Development Permit Panel

1. Development Permit 16-753377

Report to Development Permit Panel

Application by Platform Properties (Steveston) Ltd. and Platform Properties (Steveston Residential) Ltd. for a Development Permit and Heritage Alteration Permit at 3471 Moncton Street, 12040 & 12060 3rd Avenue and 3560, 3580 & 3600

Typical Roof Deck Access Detail Section Scale: 1/4" = 1-0"

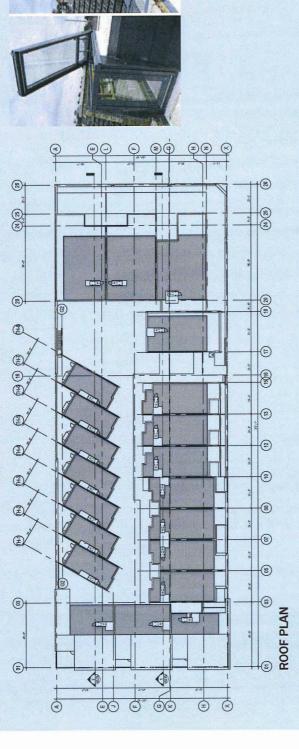
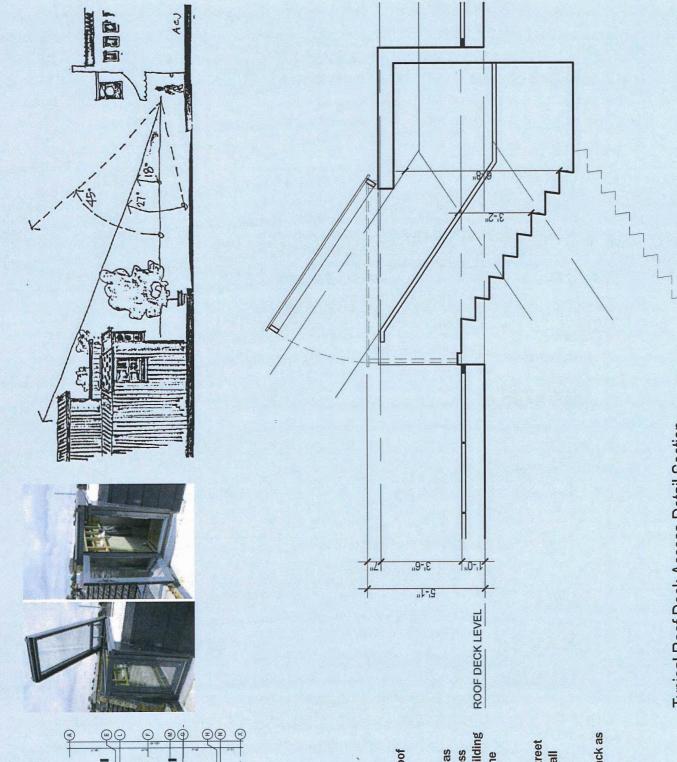
- drawing package circulated by the applicant is well thought out;
- the project is challenging due to the significant pedestrian realm and ratio of building with active street frontage versus inactive areas at grade;
- if not a City requirement, consider increasing the scale of the low-profile opening roof hatches to improve the residents' access to the roof decks of residential units:

This is a valid point, and a point we support. The current stair accesses provide functional access to the roof top decks with a sensitivity to height variances - We would need City Staff support to pursue full-height stair access.
